PROJECT NAME: Lift Station Renewal / Replacement Project – Woodway #1 Lift Station Replacement

PROJECT NO: R-000267-109B-4

ADDENDUM NO. 1

Date of Addendum: 4/17/15

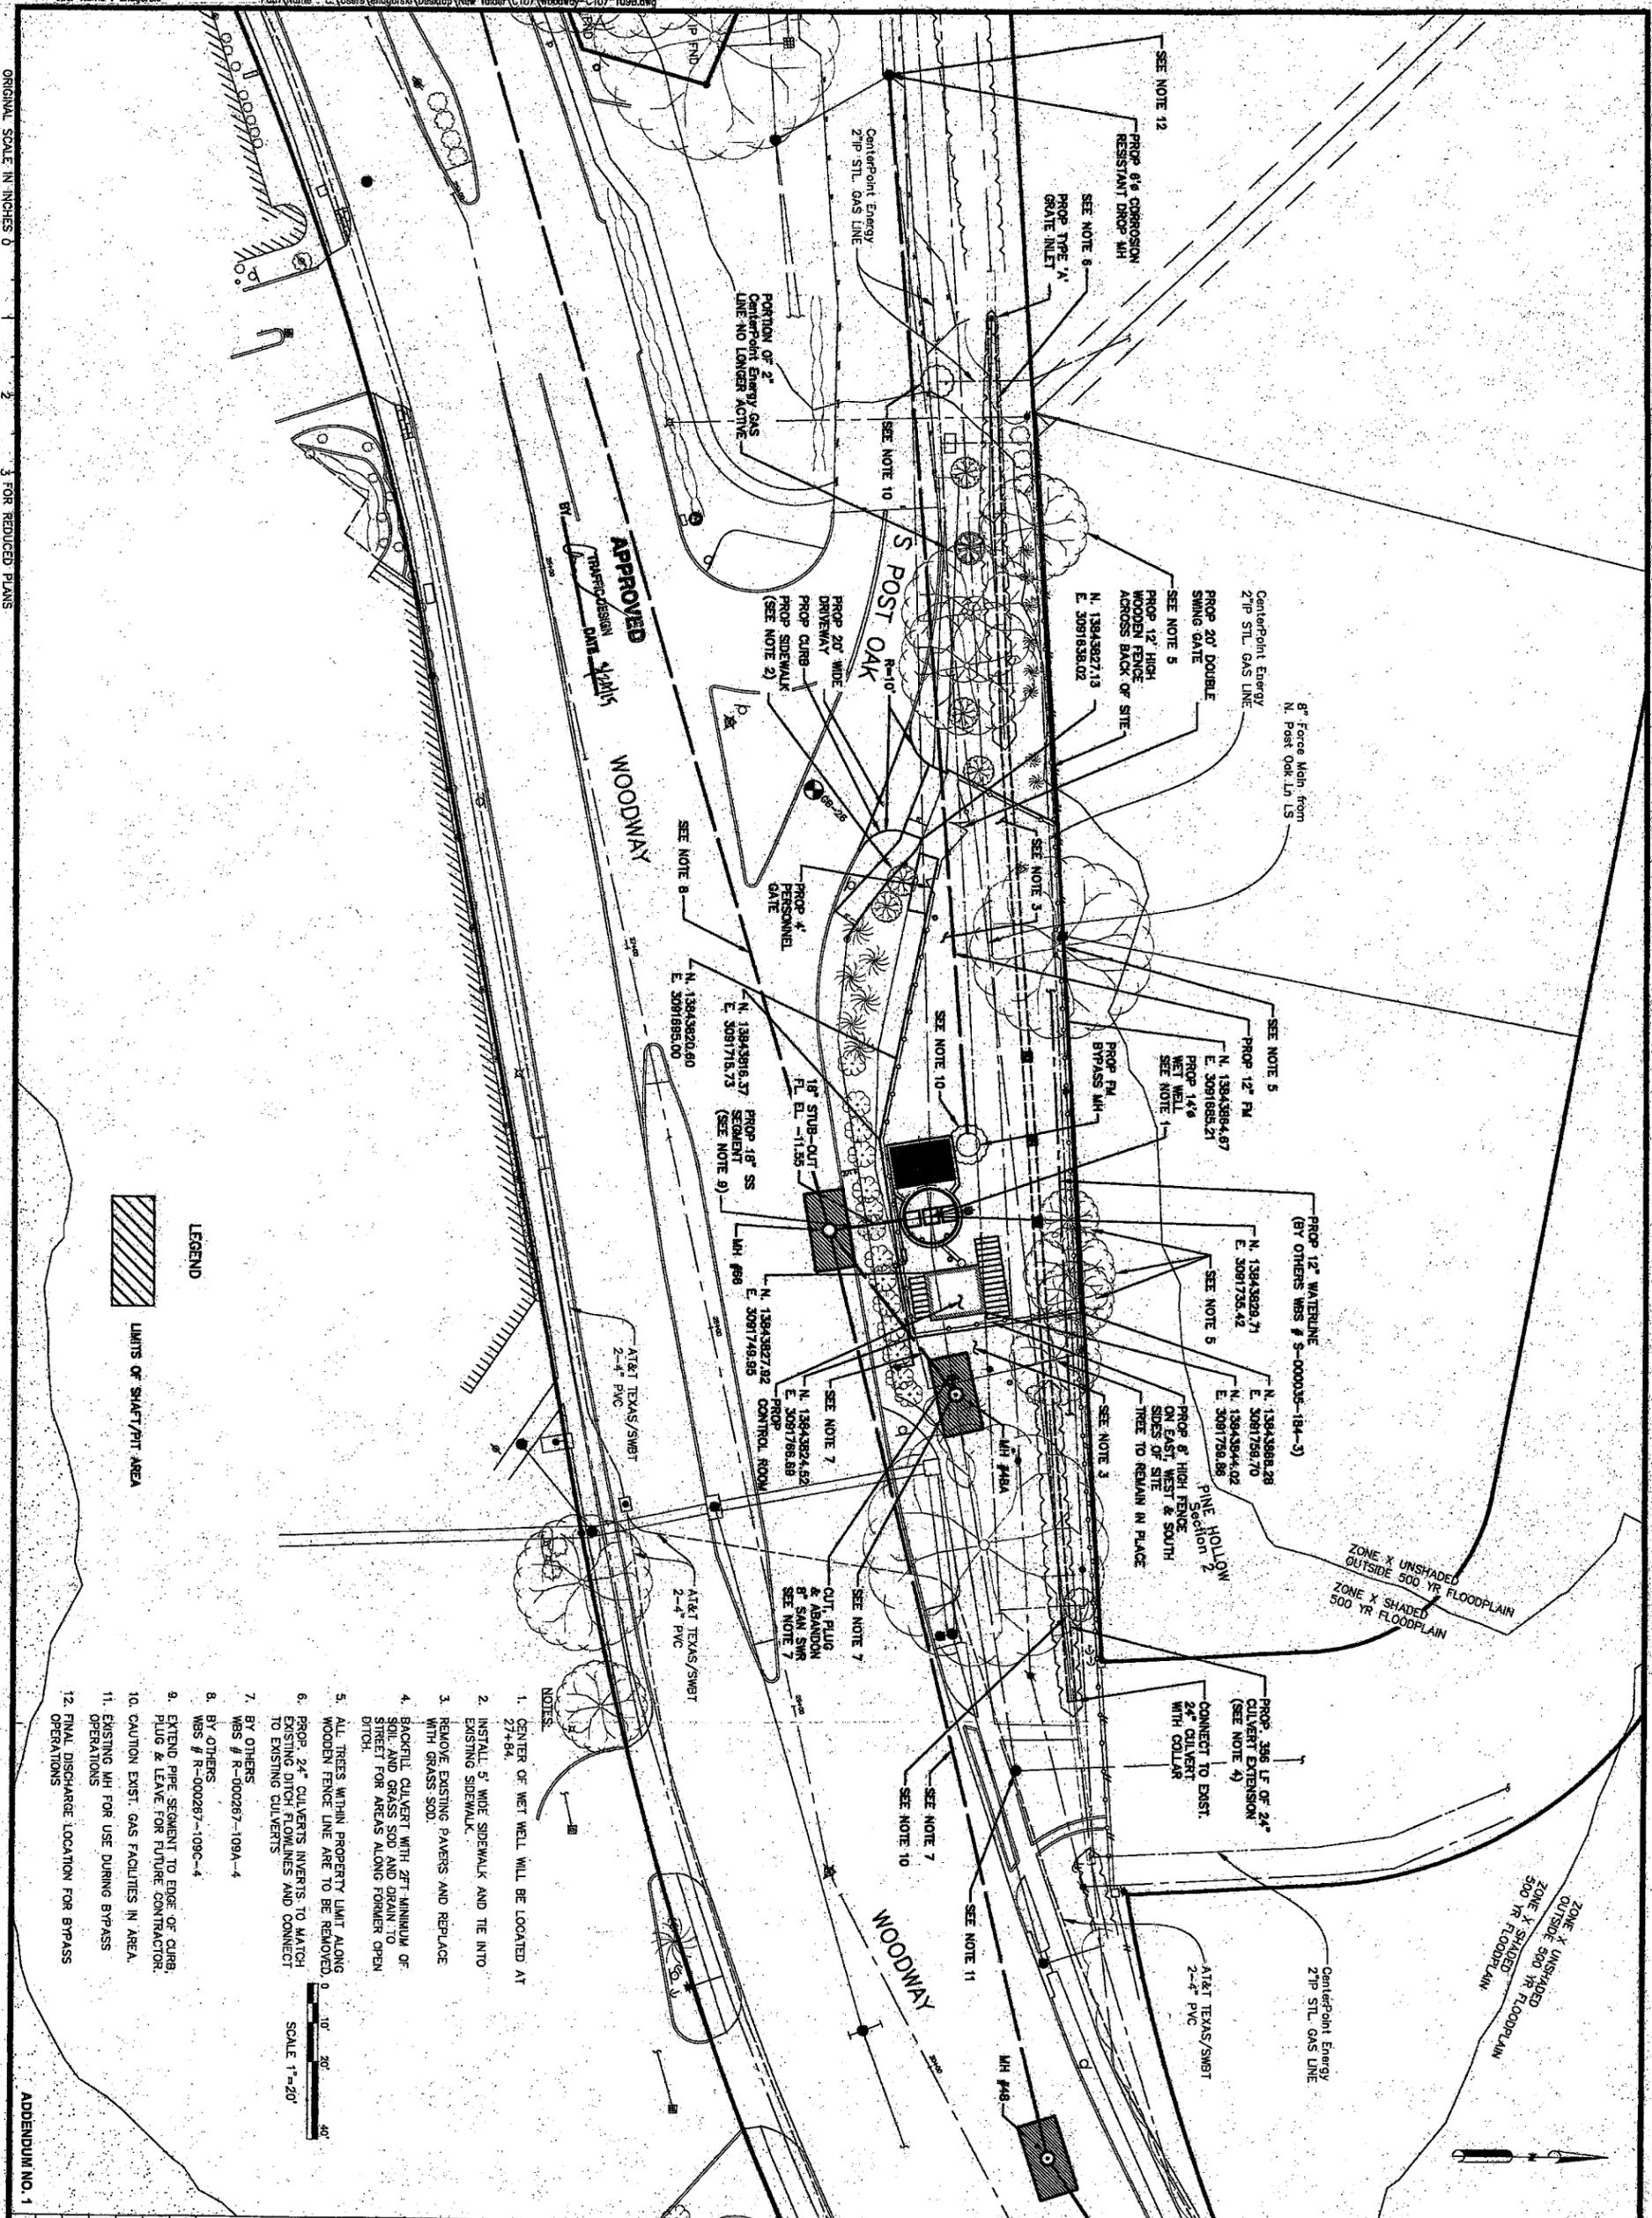
4. Plan Sheet C107 titled "Woodway L.S. Prop. Overall Improvements" – Remove and Replace this sheet in its entirety.
5. Plan Sheet S8 titled "Control Building, Wall/Footing Plan & Section"- Add to Plan Set.
6. Plan Sheet E7 titled "3 Pump Single Line Diagram"- Remove and Replace this sheet in its entirety.
7. Plan Sheet E14 titled "Conduit Schedule For 480V 3 Pump System"- Remove and Replace this sheet in its entirety.
8. Plan Sheet E15 titled "Device Rating Schedule For 3 Pump System"- Remove and Replace this sheet in its entirety.
9. Plan Sheet D12 titled "Concrete Paving Details 3"- Remove and Replace this sheet in its entirety.

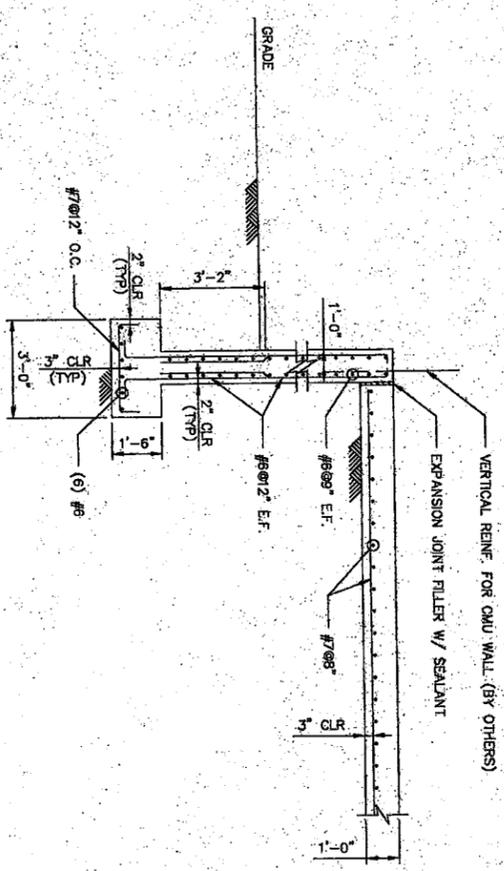
20. Question from Contractor: What size, type of reinforcing or other related construction information is required for the electrical building pad?

Response: Sheet S8 titled "Control Building, Wall/Footing Plan & Section" has been added to the Plan Set and provides the necessary information for construction of the electrical building pad.
